Addendum No. 1
Rock River Water Reclamation District
Plant Roadway Replacement 2019
Capital Project No. 2006

This Addendum Number 1, dated May 6, 2019, for the above referenced project, supersedes all contrary and conflicting information in the specifications and contract documents, which are hereby supplemented or revised as follows:

PLANT ROADWAY REPLACEMENT 2019

CAPITAL PROJECT #2006

Sheet No.
4 OF 12
Date
5/6/2019

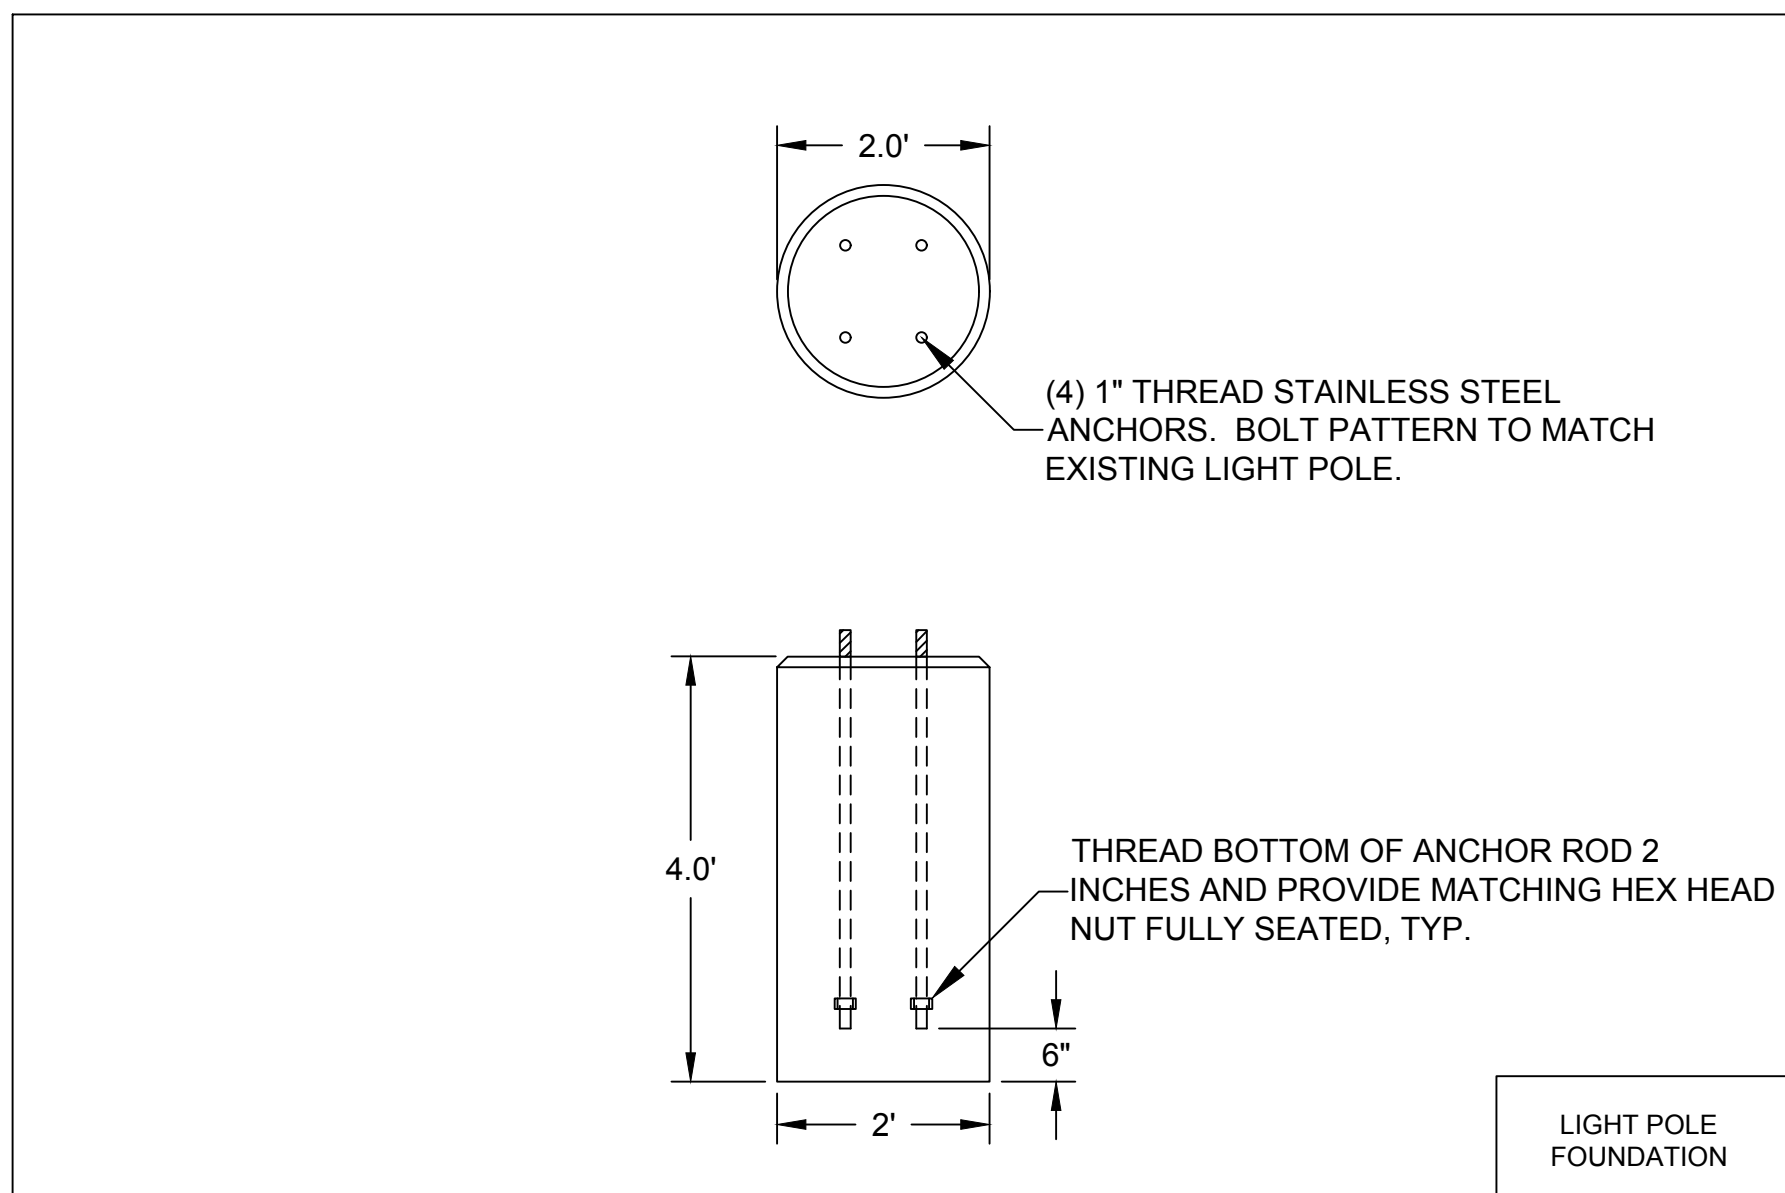
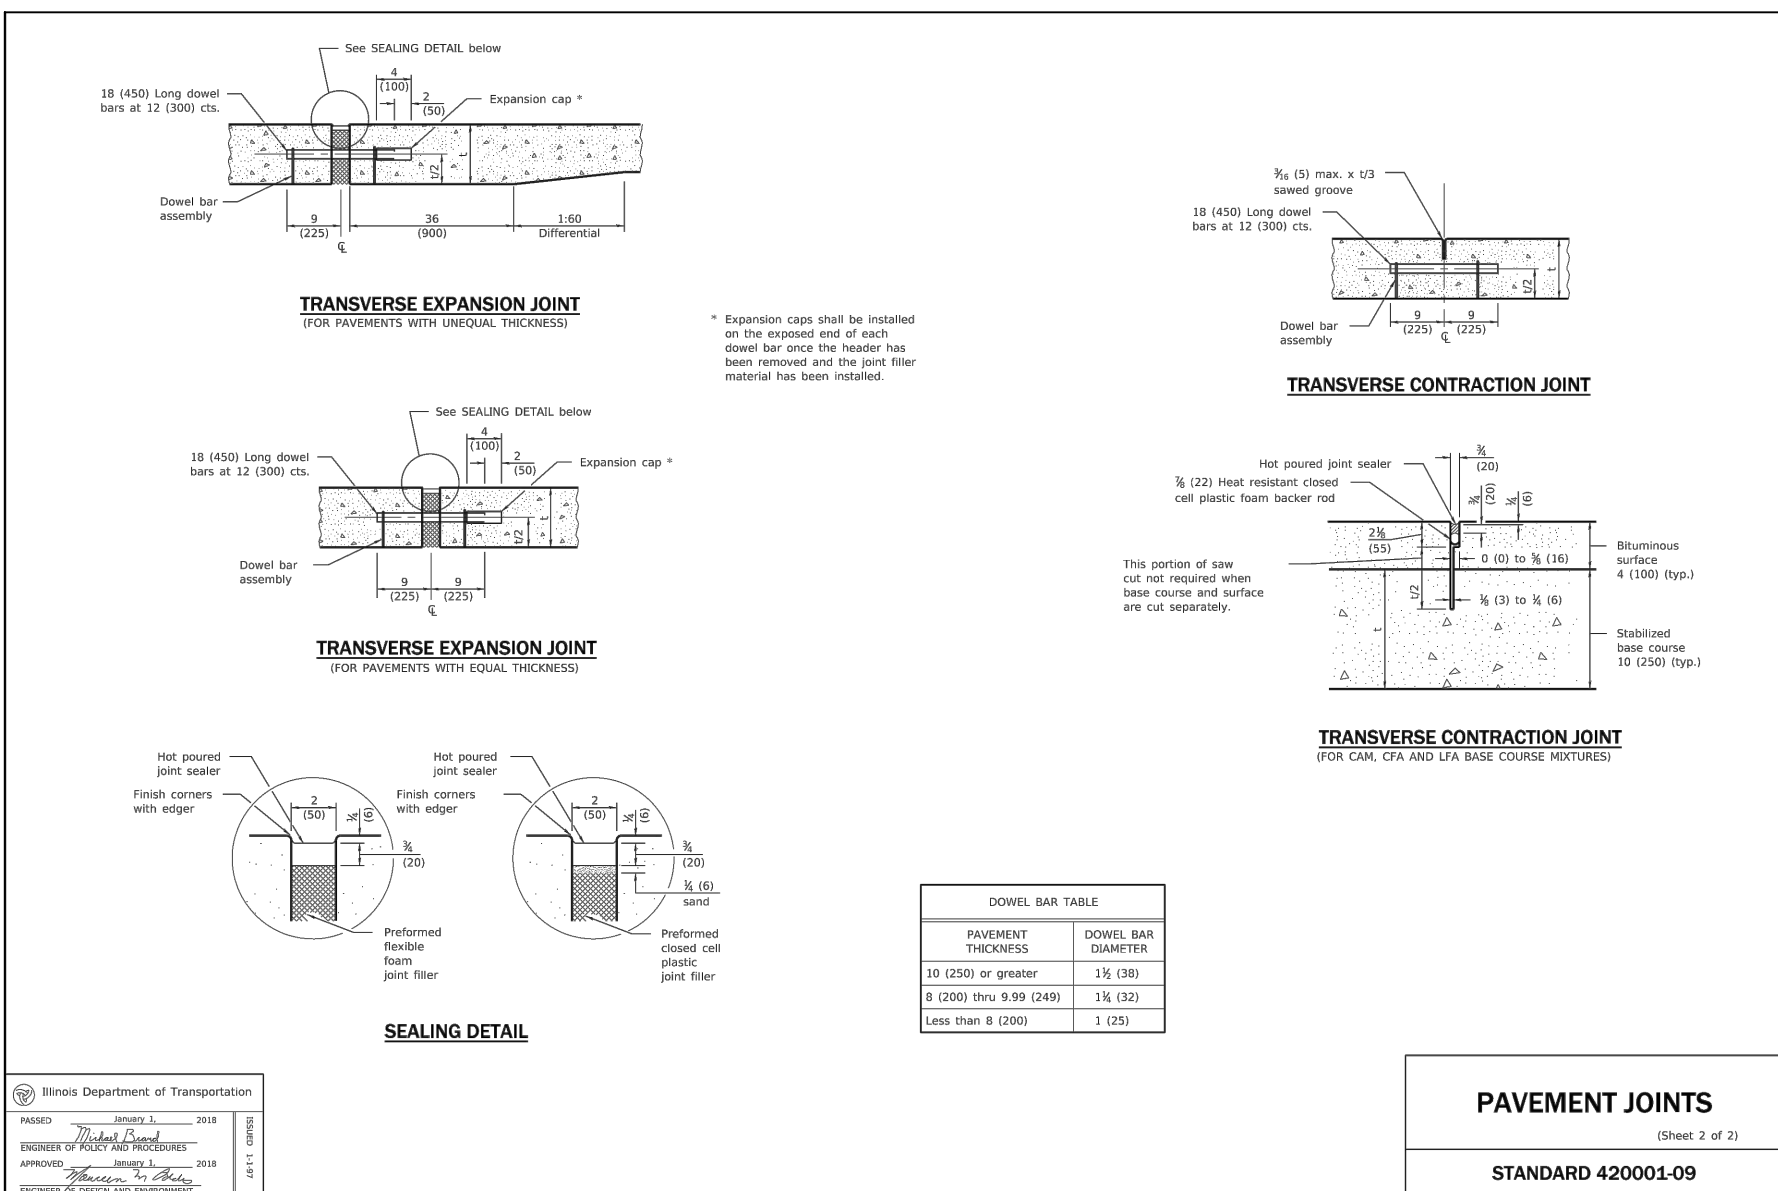
Sheet 4 of 12: EXISTING CONDITIONS & REMOVALS

1. Plan view has been updated to reflect the existing light pole foundation located at STA 101+97, 3' LT shall be abandoned in place. District staff will remove the light pole prior to construction.

| No. | DATE | REVISION | INT. |
|-----|--------|--|------|
| 1 | 5/6/19 | ADDED NOTE LIGHT POLE TO BE REM PRIOR TO CONST. @ 102+00 3' LT PER AD. #1. | KG |
